CCK-2669-23 ADDENDUM# 1 11/23/2022

UK Indoor Track Facility

CCK-2669-23 Indoor Track JRA Project No. 202258 UK Project 2584.0 University of Kentucky Lexington, Kentucky

The Addendum will form a part of the Contract Documents and modifies the original Bidding Documents dated October 2022.

GENERAL GRADING AND DRAINAGE NOTES

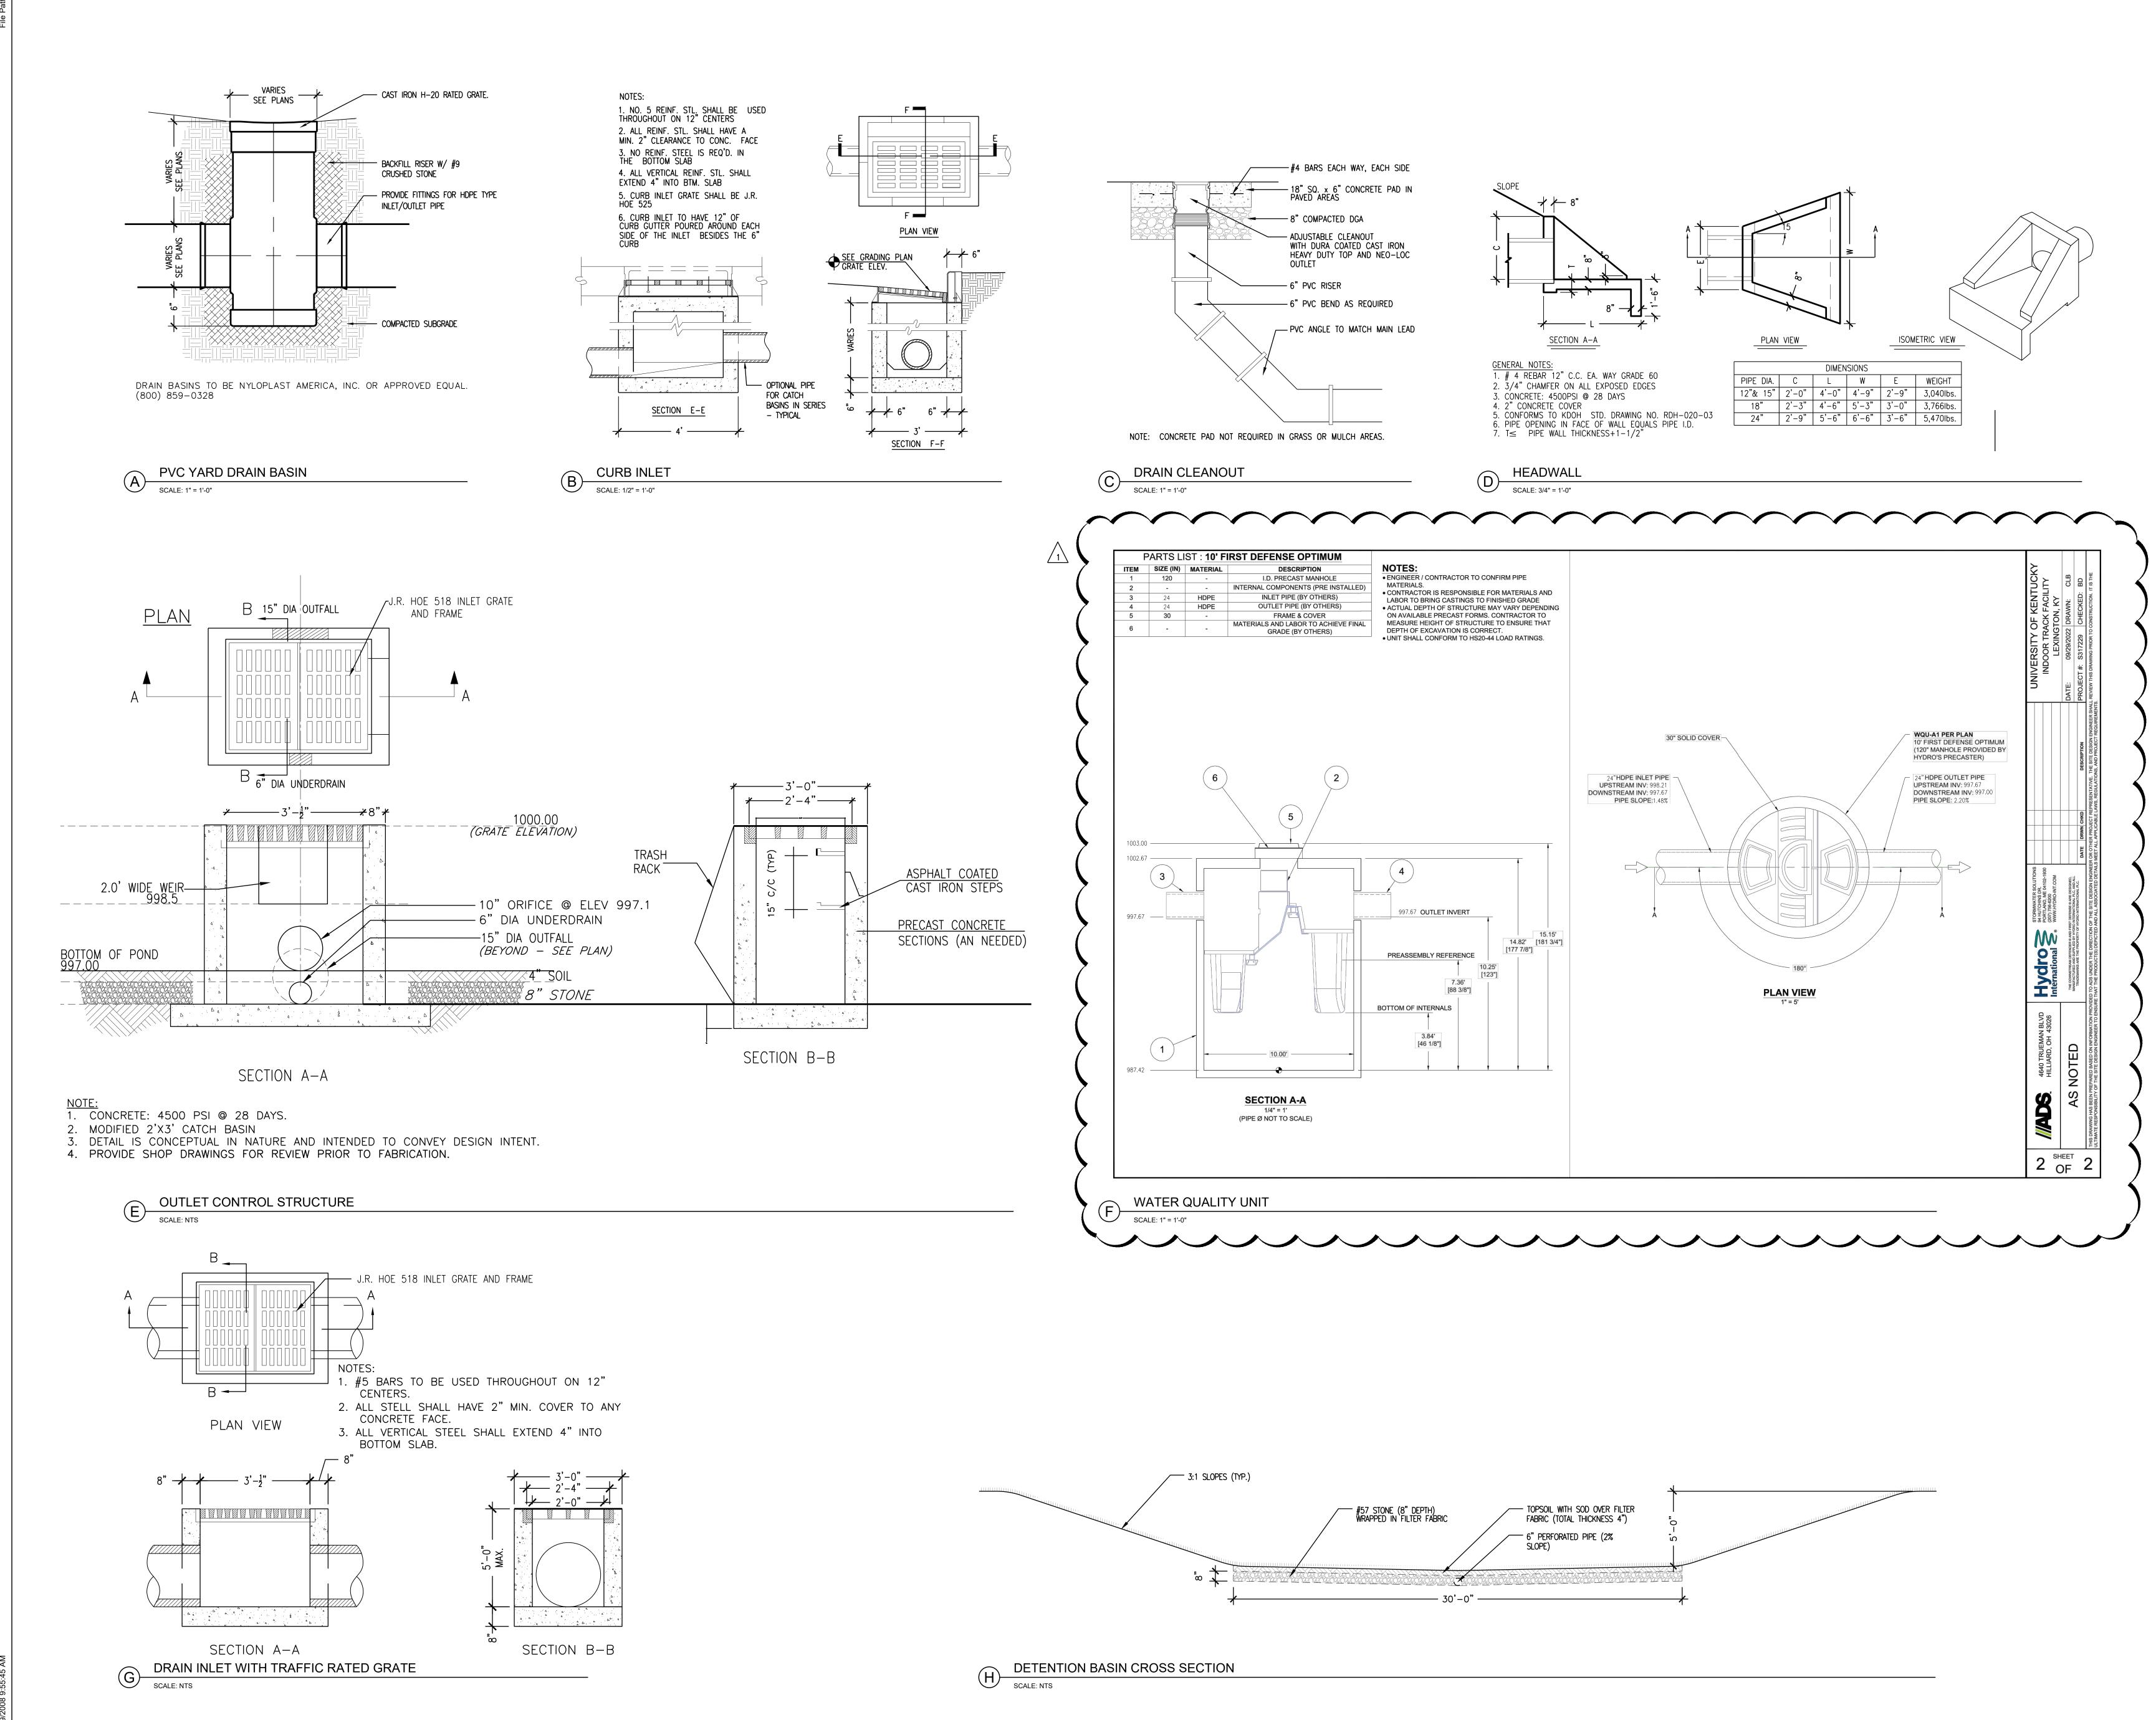
Refer to drawing sheet C-201. Replace this sheet in its entirety with attached revised sheet C-201. The original contours for existing grades have been replaced with post demolition survey contours. The proposed contours have been revised to react to the post demolition topo survey. Specific revisions include revised storm piping and structures throughout the site, revised coded notes #6 & #7.

C WASHOUT PIT SCALE: 1/2" = 1'-0"

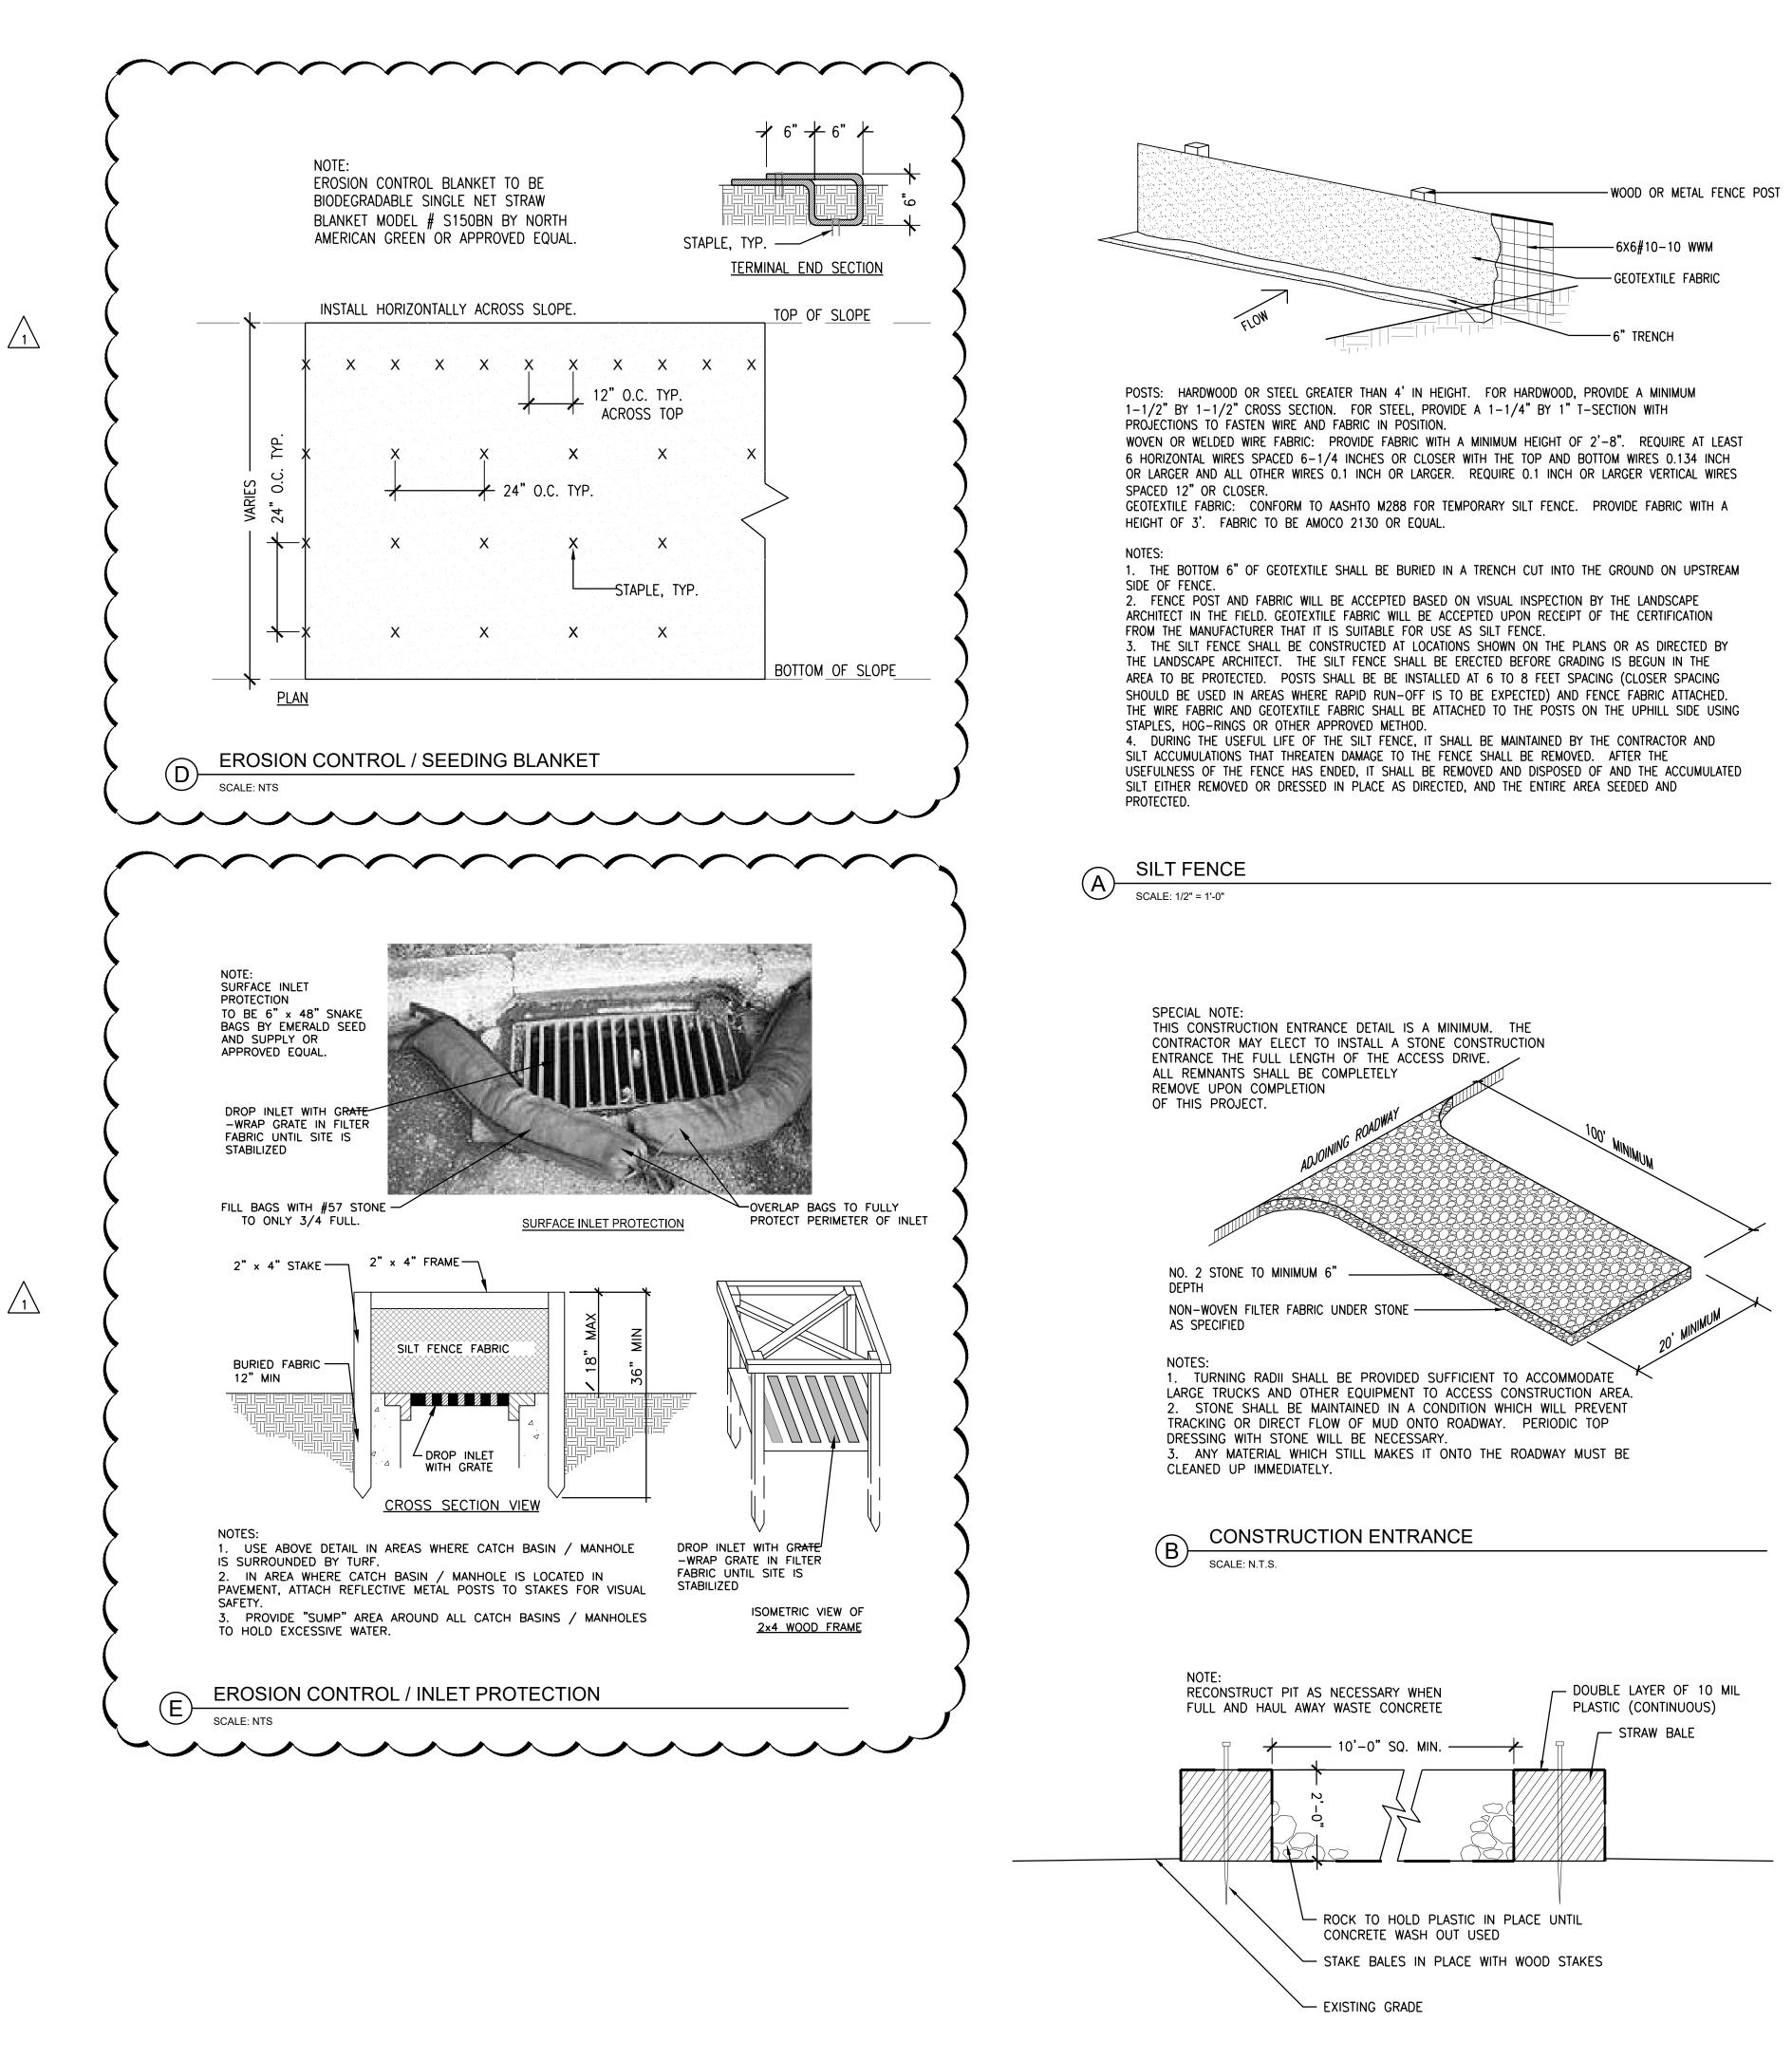
Refer to drawing sheet C-302. Replace this sheet in its entirety with attached revised sheet C-302. Details D & E have been added to this sheet.

EROSION CONTROL & PHASING NOTES:

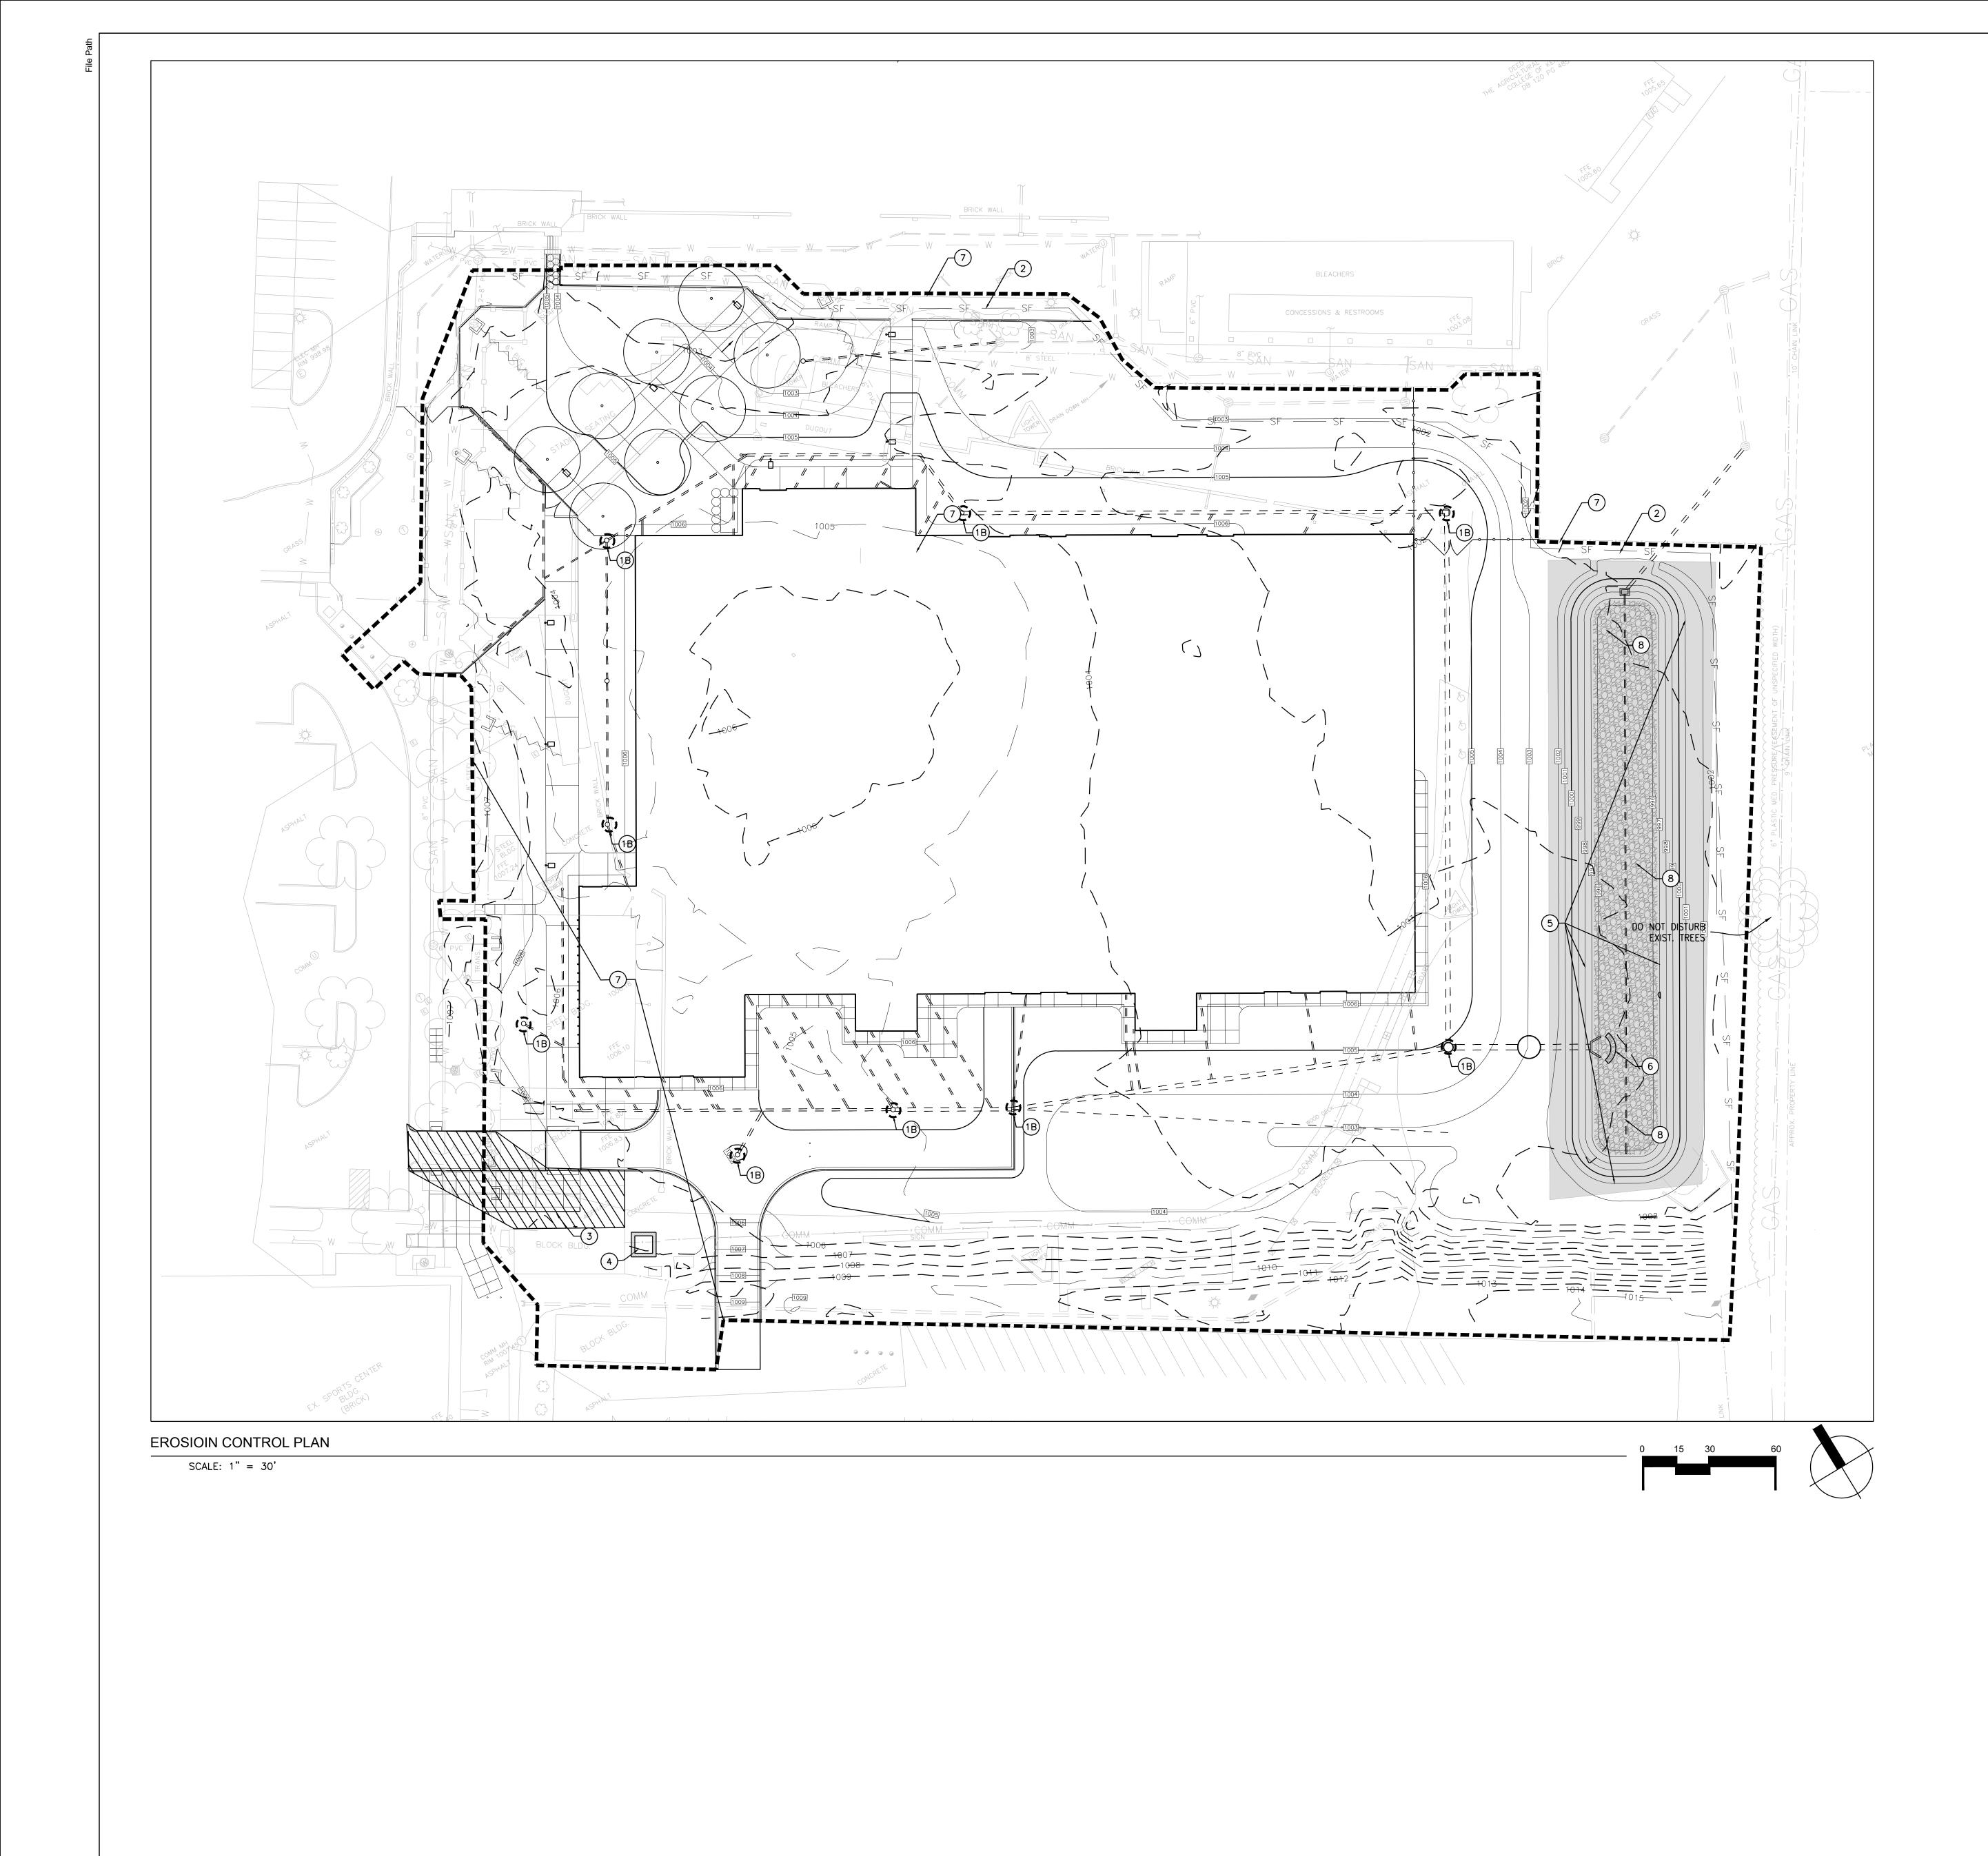
Refer to attached drawing sheet C-303: Erosion Control Plan. This is a new sheet added to the bid documents.
